Errata

T. Y. Otoshi and M. M. Franco have submitted the following errata to "DSS-13 Beam Waveguide Antenna Frequency Stability" that appeared in *The Telecommunications and Data Acquisition Progress Report 42-110*, vol. April–June 1992, pp. 151-162.

Fig. 7. Wind direction relative to the BWS antenna main axis during test with the GSTAR I geotstationary satellite.

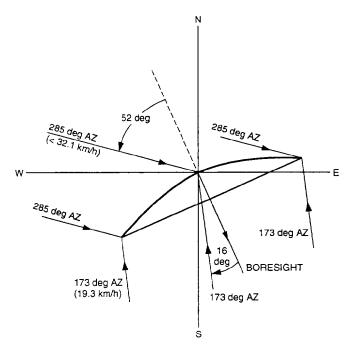
The changes are made after discovering that the instruments at DSS 13 give wind direction as coming from instead of going towards an indicated direction. Figures 7 and 14 of the original article should be replaced by the ones that follow.

In the discussion of wind direction on pages 152 and 153, the terms "front side" and "back side" of the antenna should be interchanged. Also, the phrase "blowing into the face" should be replaced with "blowing into the back."
